ADDENDUM NO. 02

DATE: July 25, 2024

PROJECT: Goshen Public Library

GOSHEN PUBLIC LIBRARY
CENTRAL PLANT REPLACEMENT
ADDENDUM 02

Stormwater Management Plan

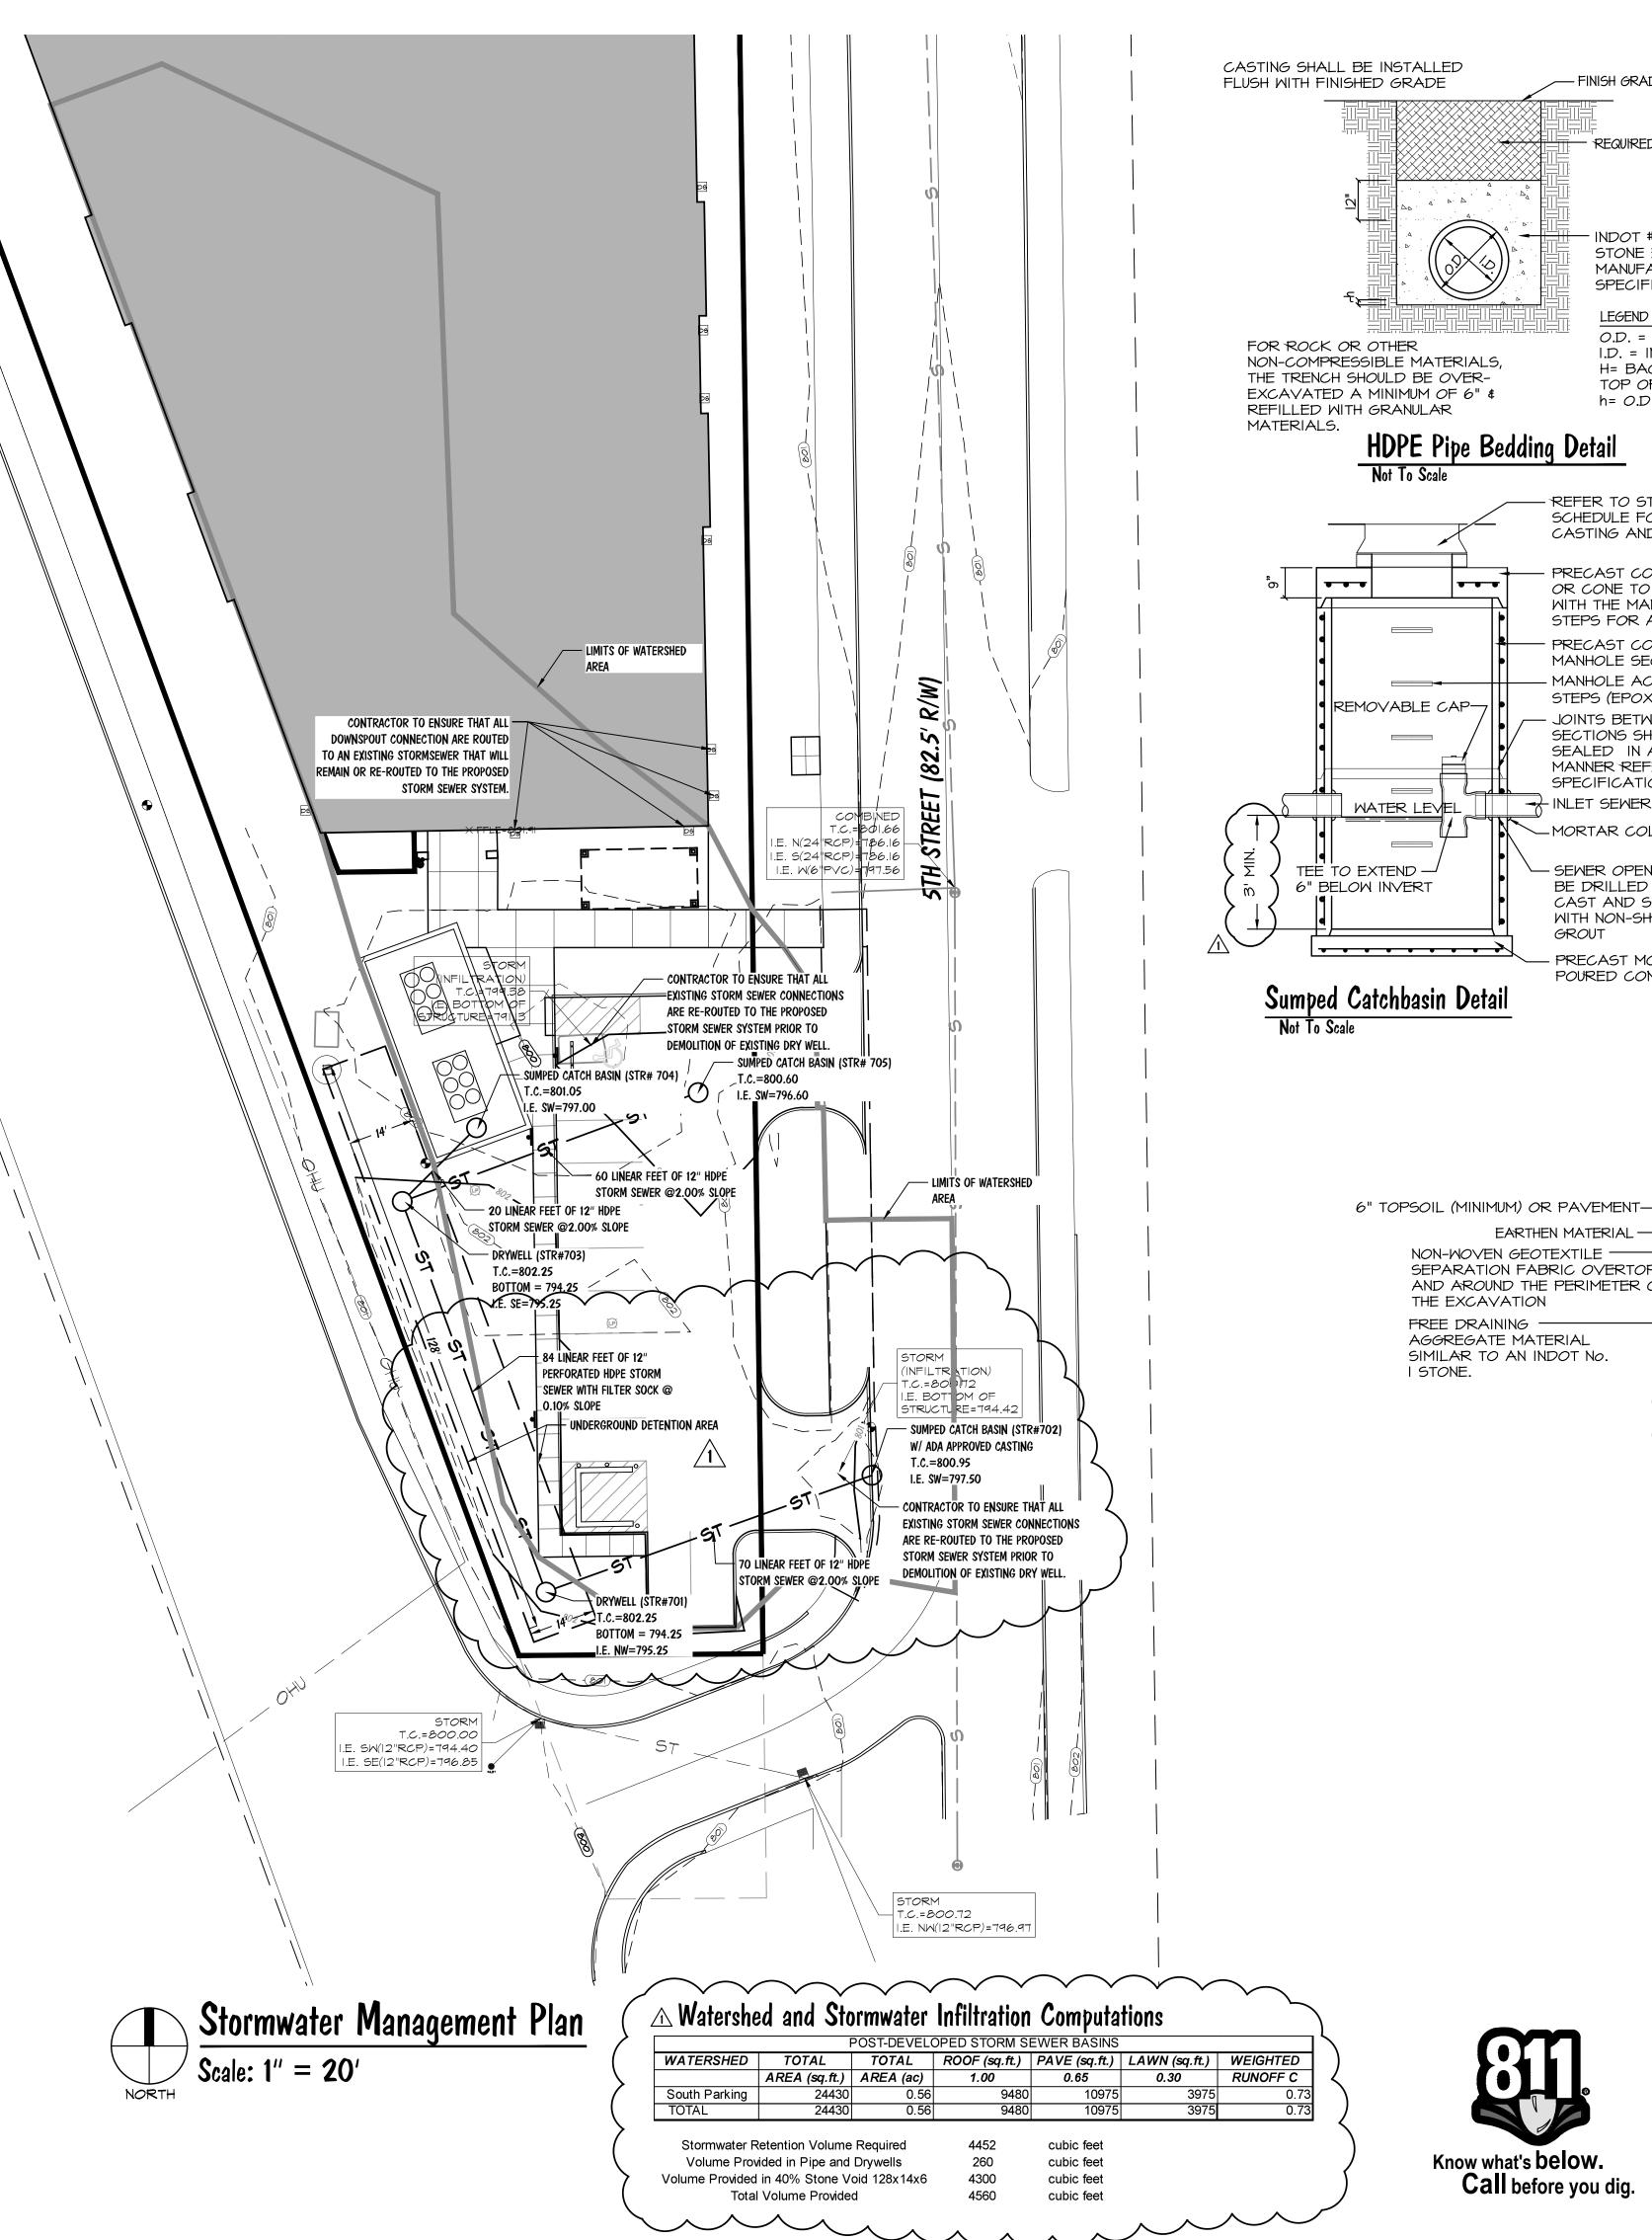
- 1. SHEET C4.1 STORMWATER MANAGEMENT PLAN
 - a. Add Storm Sewer Structure Schedule

A Storm Sewer Structure Schedule

STR.#	SIZE	DETAIL/NOTES	MANUFACTURE	GRATE
701	48"	DRYWELL	EJCO	1020M2
702	30"	SUMPED CATCH BASIN	EJCO	1020M3
703	48"	DRYWELL	EJCO	1020M2
704	30"	SUMPED CATCH BASIN	EJCO	1020M2
705	30"	GIMPED CATCH BAGIN	FKO	IO20M2
